# Memorandum

To	Douglas Shire Council and Department of State Development, Manufacturing, Infrastructure and Planning		
From	Sarah Wilson - GHD	Tel	+61 7 5413 8133
Subject	Response to information request from Douglas Shire Council (DSC) and Department of State Development, Manufacturing, Infrastructure and Planning (DSDMIP) Wangetti Trail SP1 - Combined Development Application Response to request for information 1909-13127 SRA	Job no.	4132458

We refer to the Development Application Council Ref: CA3212/2019 and SARA Ref:1909-13127 SRA associated with the proposed Wangetti Trail SP1 and provide responses to the information request issued by Douglas Shire Council (DSC) and Department of State Development, Manufacturing, Infrastructure and Planning (DSDMIP) in accordance with Part 3, Section 13.1 of the Development Assessment Rules.

Print date: 31 Oct 2019 - 12:19

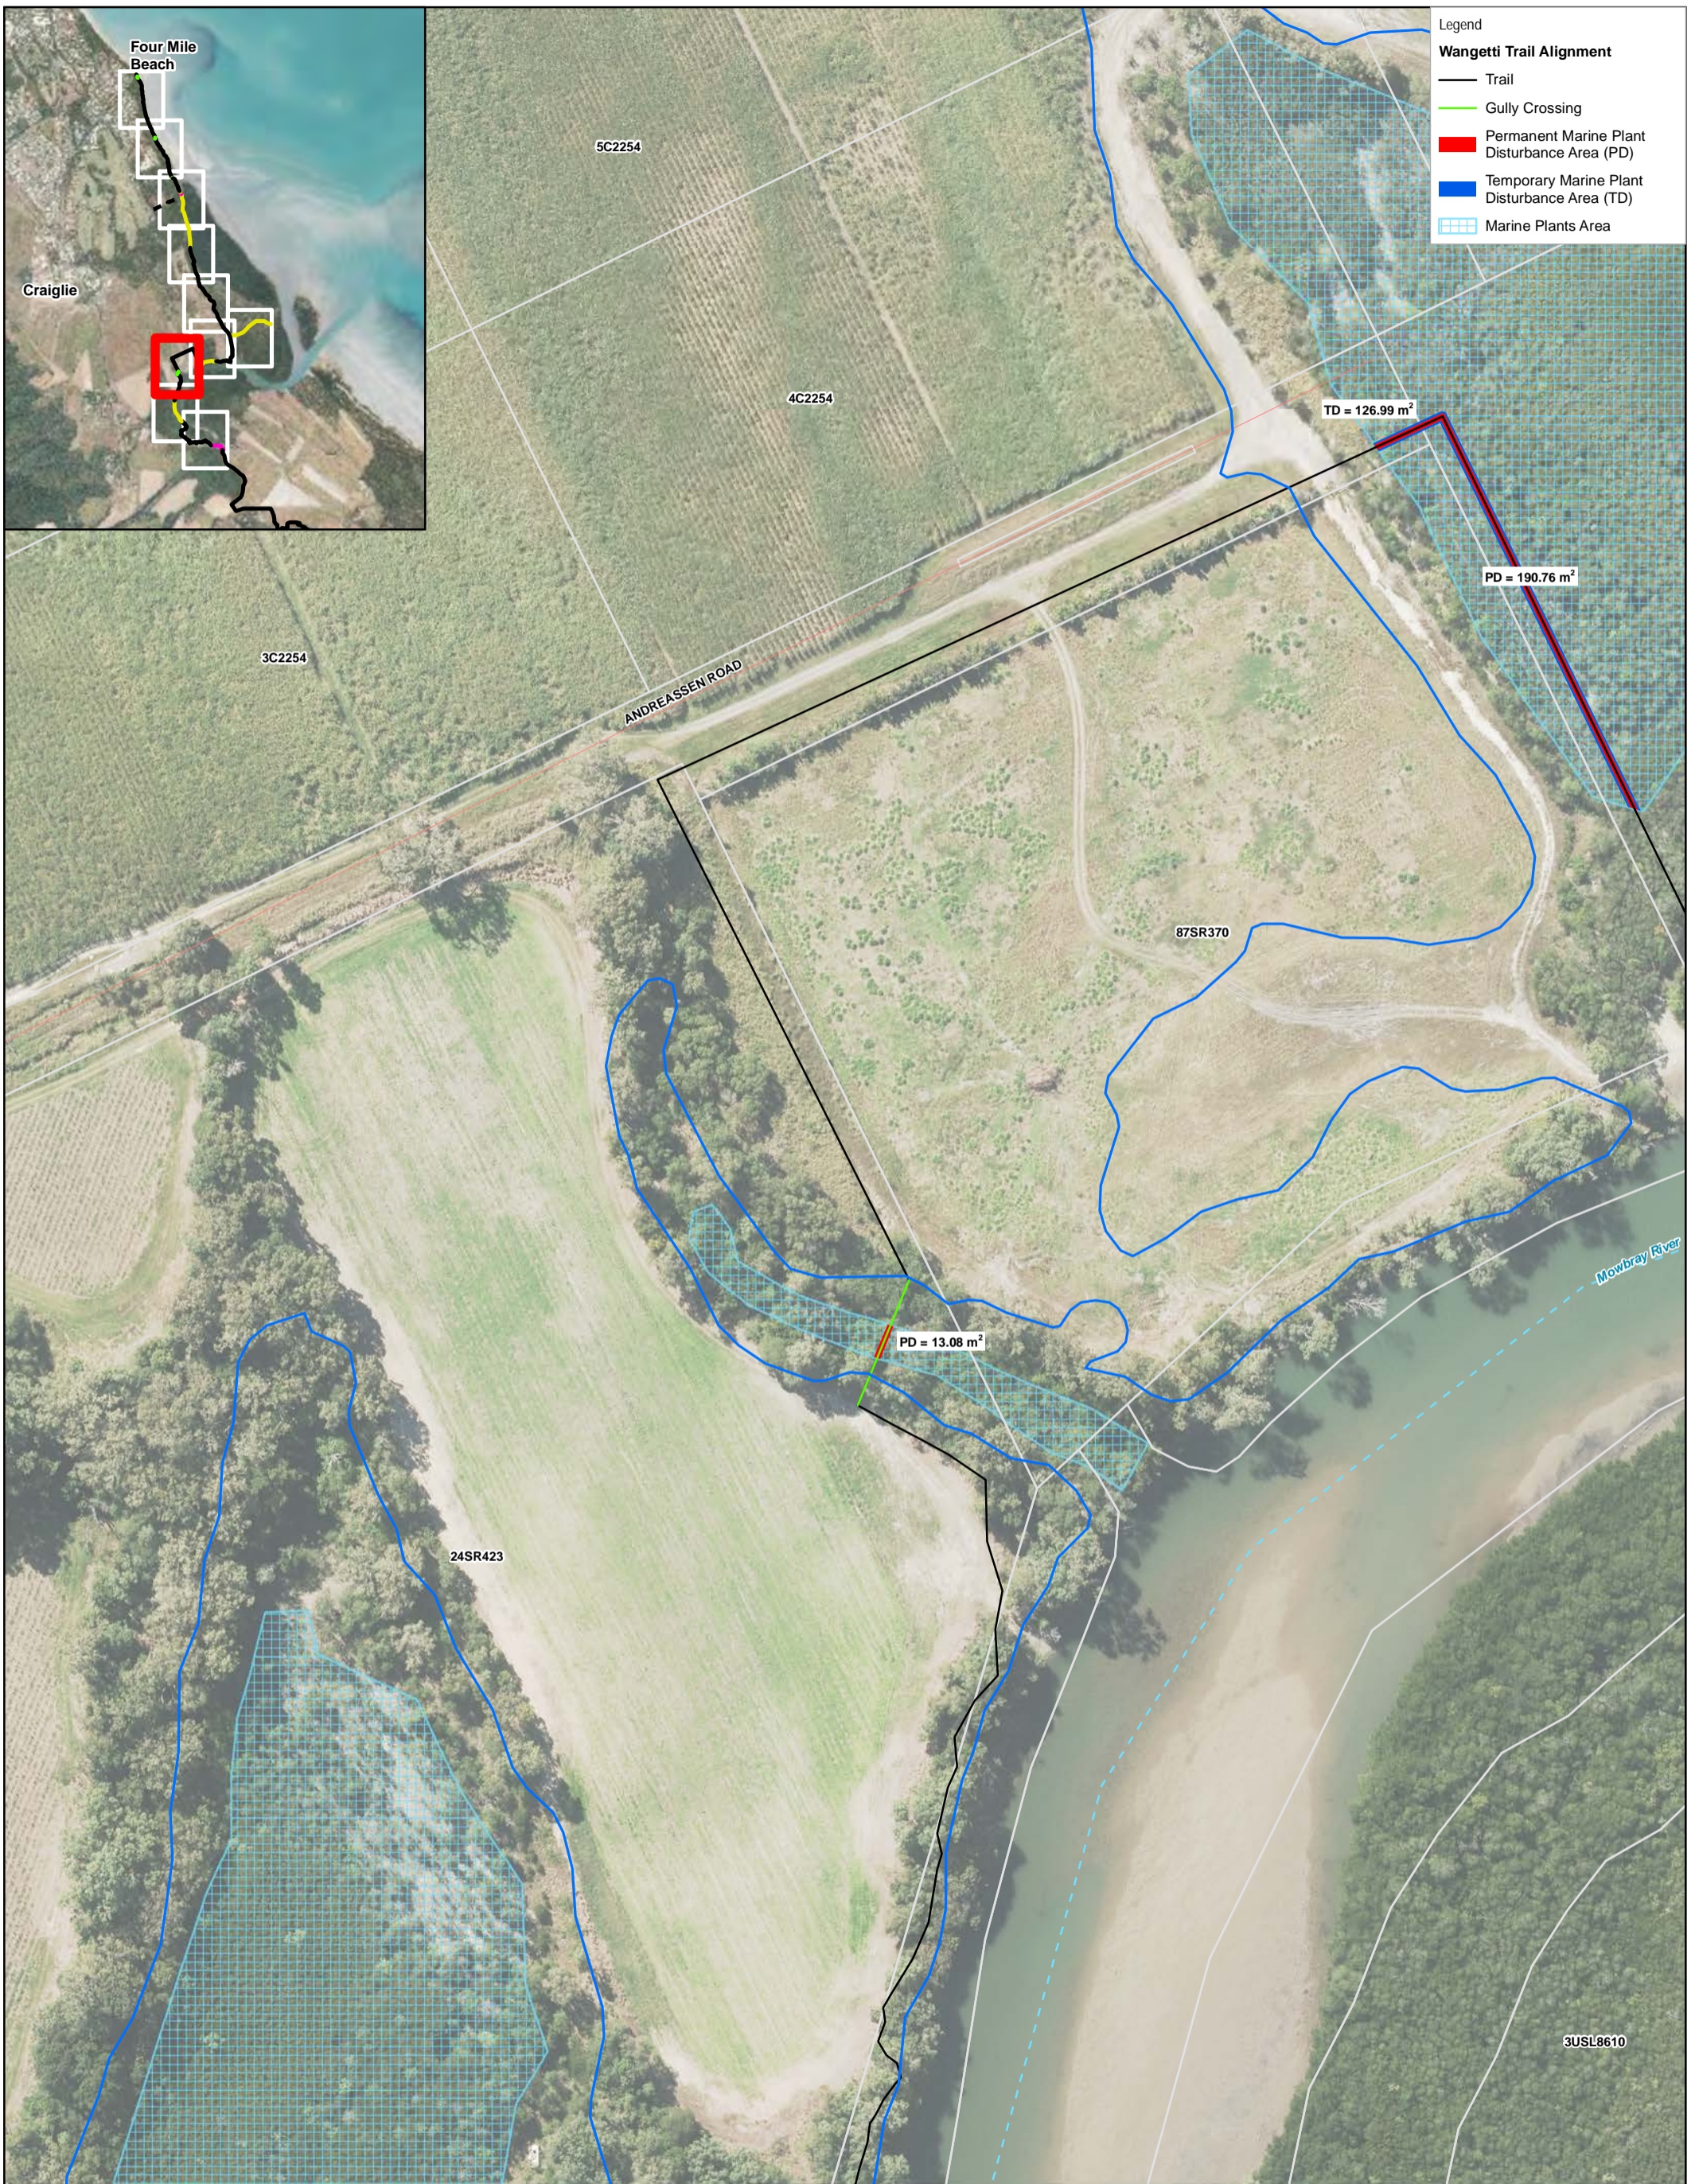
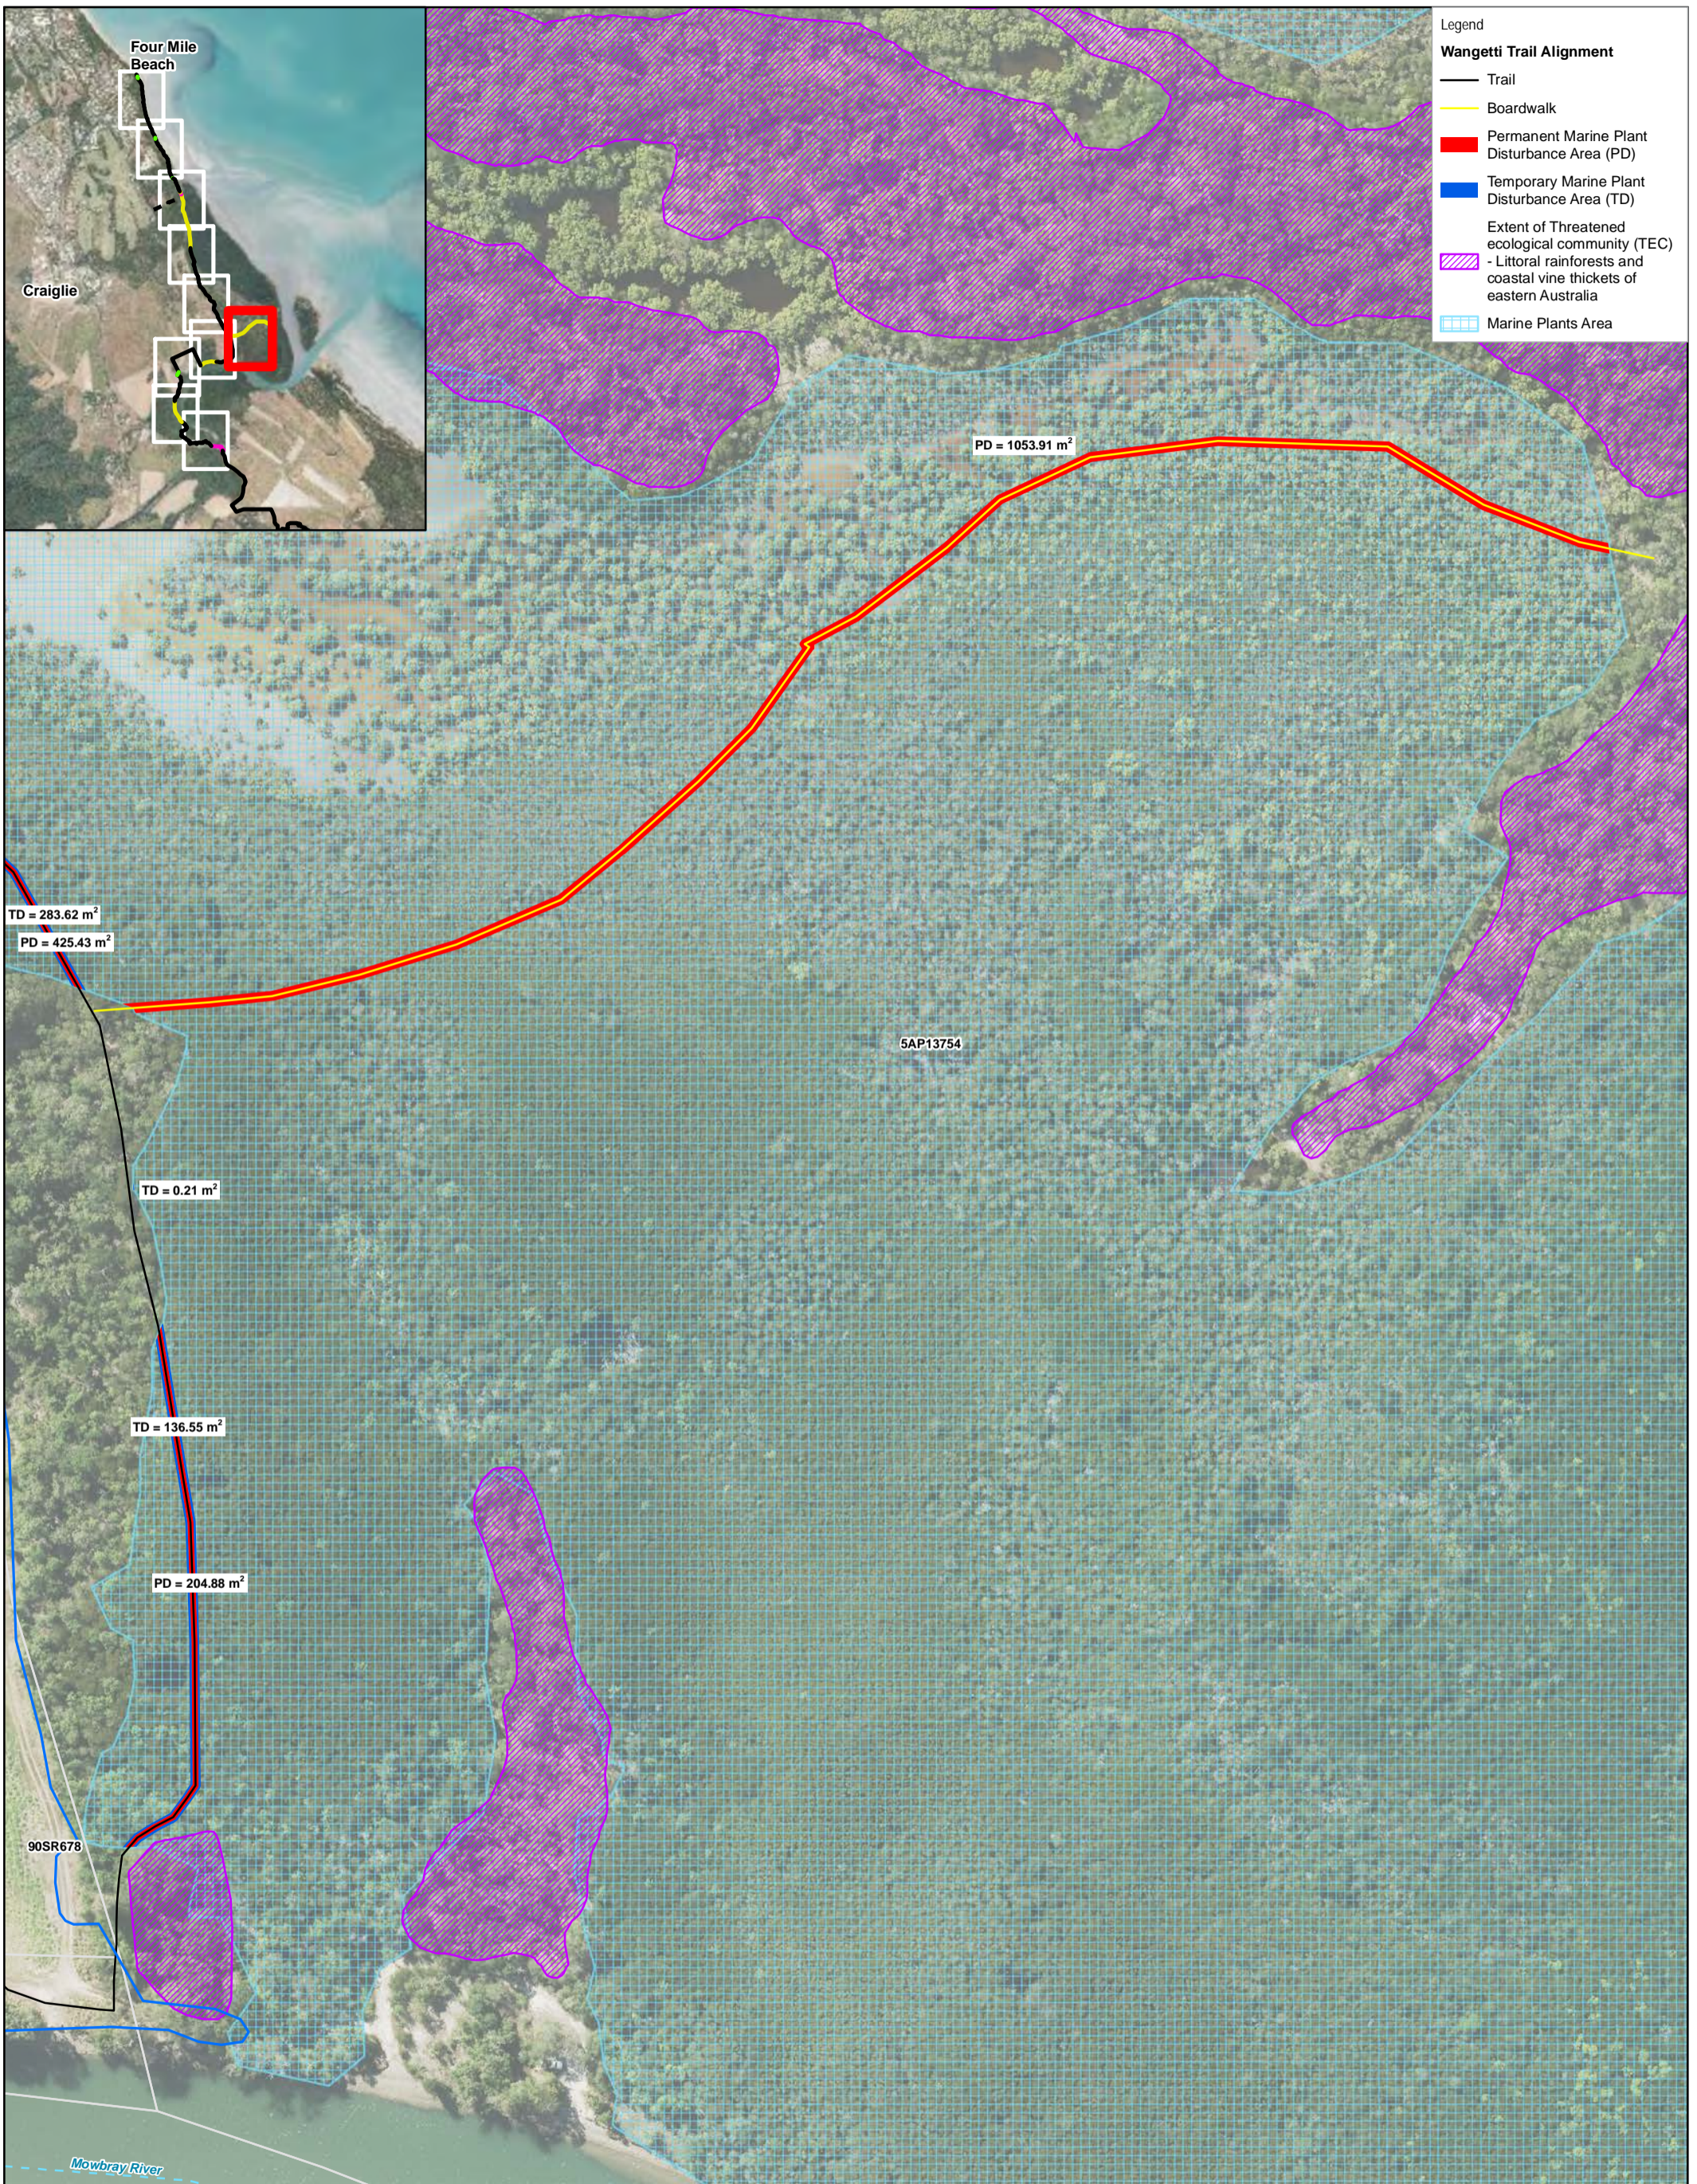
- b) *Provide maps identifying all locations where the trail will be constructed within TEC communities.*
- c) *Identify all locations where crushed rock will be used to construct the track and any creek crossings where rocks are proposed.*
- d) *Provide detailed information of the compacted trail construction and the impacts it will have to the existing profiles of tidal land.*
- e) *Demonstrate the compacted trail will not impact tidal flow and fragment tidal lands.*
- f) *Provide information of the existing tidal land levels (i.e. contour lines).*
- g) *Discuss the natural tidal inundation levels and connectivity of all adjacent habitat under elevated flow events. This discussion should include any impacts the proposed works will have on the existing connectivity.*
- h) *Discuss all potential impacts the proposed works will have on marine plants and fisheries resources.*

**Item 3 (c) Provide the individual marine plant disturbance area in meters squared (m<sup>2</sup>) for each works component.**

Figure 2 shows the location of the proposed trail and boardwalk and the location of threatened ecological community (TEC) - Littoral rainforests and coastal vine thickets of eastern Australia. The SP1 alignment has been designed to predominantly avoid areas of TEC, however the trail intersects with a small area of TEC, located approximately 600 m north of the Mowbray River. The TEC was not previously mapped in government databases and was recorded during the site investigation of the area. Based on the composition of the vegetation within the TEC area, it was determined not to contain high fisheries significant plants.

A breakdown of the marine plant disturbance including temporary and permanent disturbance has been provided in Table 3-2 of the Environment Assessment Stage 2 Wangetti Trail Planning Report for Operational Work - SP1 Marine Plant Disturbance Report and is outlined in Table 5 below and shown in Figure 2.
